# California High-Speed Train Project

RFP No.: HSR 11-16  
Design Variance Report

06/04/2012 ADDENDUM 2 - RFP HSR 11-16

Fresno Station Crossover  
Distance from Station

**CALIFORNIA HIGH-SPEED TRAIN PROJECT  
SIERRA SUBDIVISION**  
PACKAGE 1  
PLAN AND PROFILE  
STA. 10890+00 TO 10918+00

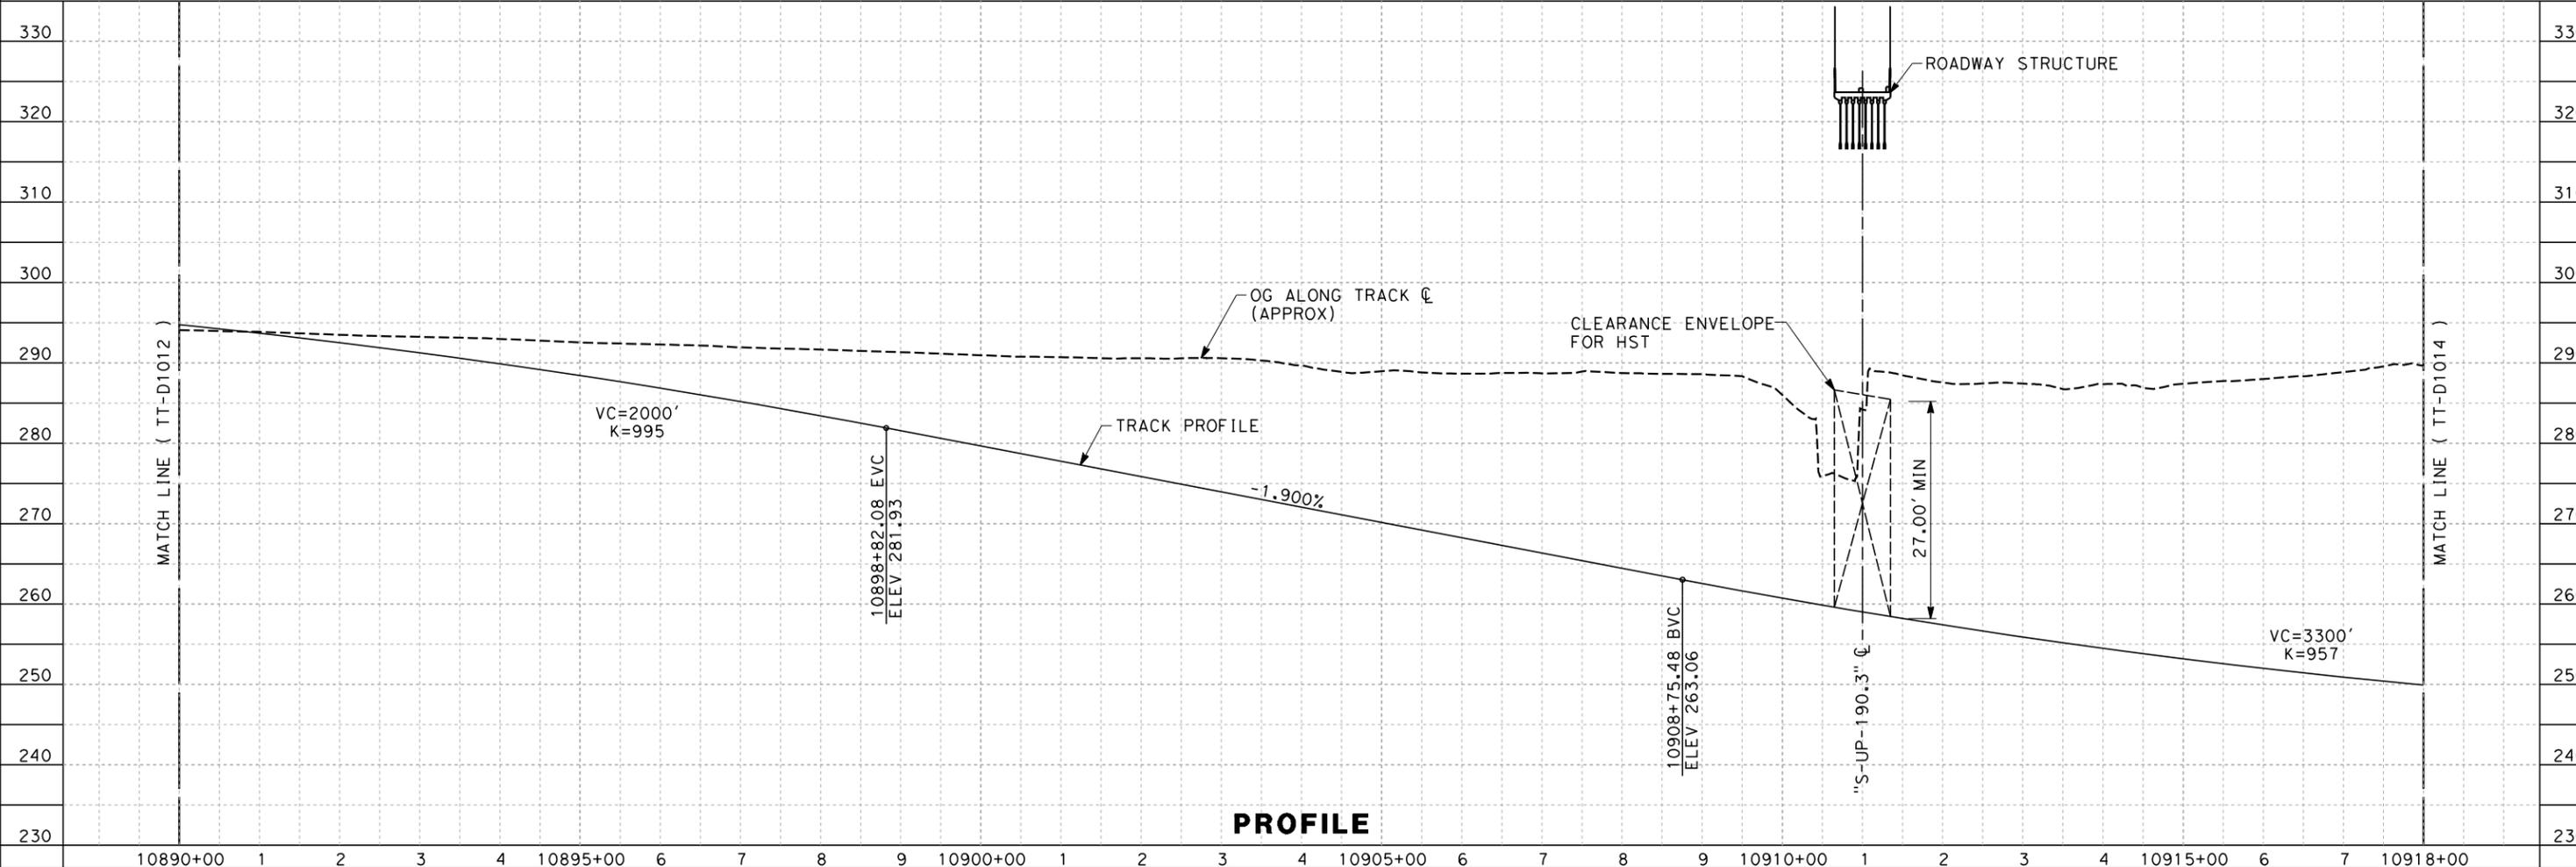
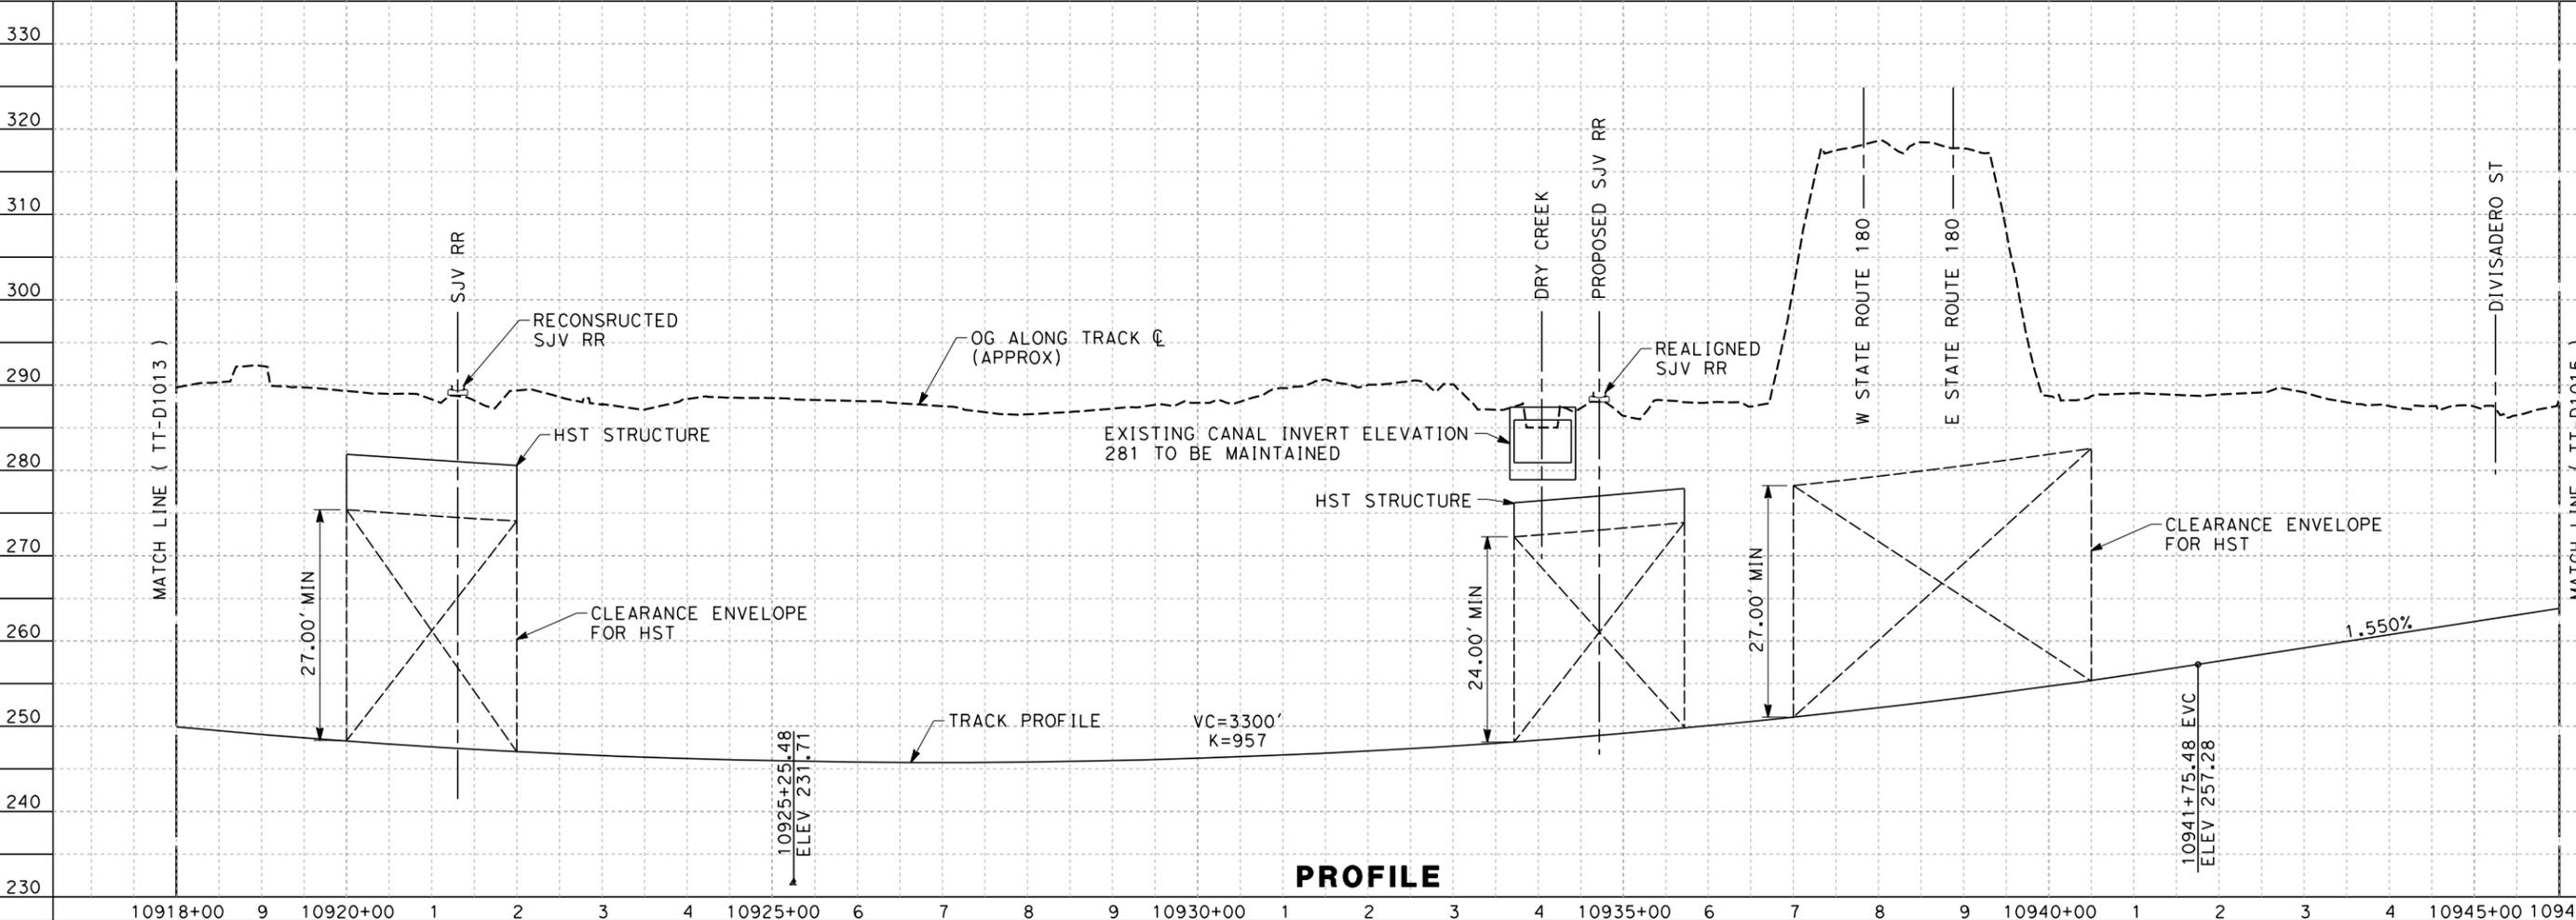
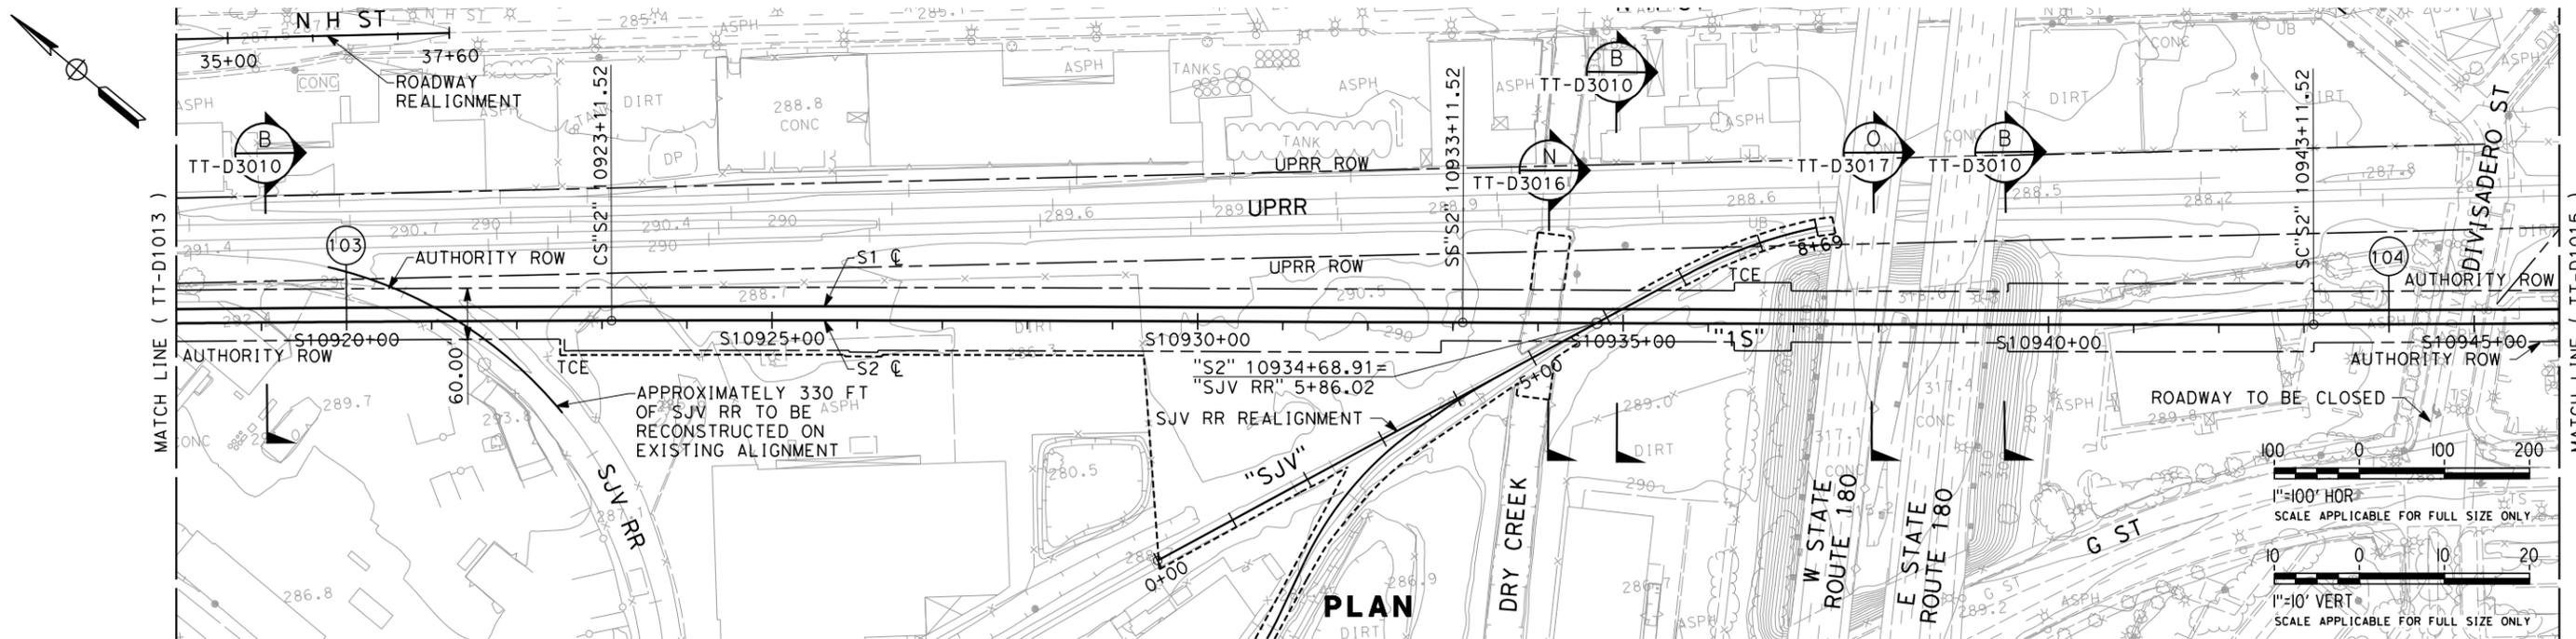
<p><b>CHSTP DESIGN REQUIREMENT</b> Include reference to drawings, design criteria, technical memos, specifications</p>	<p>TM2.1.3 – Turnouts and Station Tracks Rev 0, 06/29/09 Figure 6.1.4 stipulates the desirable run time to determine the “minimum distance between the end of station turnout and crossover turnout, where they are on the same track,” should be 1.5 seconds, or a minimum of 1 second.</p> <p>Verbal advice from EMT stated that station crossovers should not be more than a mile from the station.</p>
<p><b>DESIGN CRITERIA REQUIRING A VARIANCE</b></p>	<p>Desirable run time to determine the “minimum distance between the end of station turnout and crossover turnout, where they are on the same track,” should be 1.5 seconds, or a minimum of 1 second.</p>
<p><b>REASON FOR REQUESTING A VARIANCE</b></p>	<p>Crossovers for Fresno stations at STA 10851+72.74 to 10863+11.37 and 108664+61.37 to 10876+00.00. Station platform ends are at 10970+00. This is a maximum separation of 14,127ft.</p>

<p><b>JUSTIFICATION FOR VARIANCE</b></p>	<p>Fresno Station is centered on Mariposa St and the station platform track approaches extend from Stanislaus St to the north and Santa Clara St to the south. The high-speed rail (HSR) descends into trench immediately after Stanislaus St in order to cross under abutments supporting the SR180 overcrossing of the Union Pacific Railroad (UPRR) tracks, spur tracks belonging to the San Joaquin Valley Railroad (SJVR) Company, and a canal that crosses under both the UPRR and the SJVR.</p> <p>The HSR is on a vertical curve as the tracks descend into the trench followed by a constant gradient of only 800ft at a gradient of 1.550%, followed by another vertical curve and then another section of 1,000ft at a constant gradient of -1.900%. The HSR emerges from the trench and is back at-grade on a constant gradient of 0.110% around 9,000ft (1.7 miles) to the north of the station platform turnouts. There are no sufficiently long sections at a constant gradient within the trench to accommodate a crossover with a design speed of 110mph (i.e., 1,139ft).</p>

<p><b>PROPOSED ALTERNATIVE DESIGN</b></p>	<p>Continue an at-grade alignment between W</p>

<b>REQUIREMENT</b>	<p>Olive and the station. This would require grade separation junction to carry the SJVR spurs (if feasible) and closure of Dry Creek. SR180 would require major works to the embankments and probable reconstruction of the abutments of the bridge crossing UPRR.</p> <p>It may be feasible to provide a crossover on the 1,000-foot section of constant gradient within the trench, but this would require the imposition of an 80mph speed restriction due the short crossover. This option was not recommended.</p>
--------------------	--
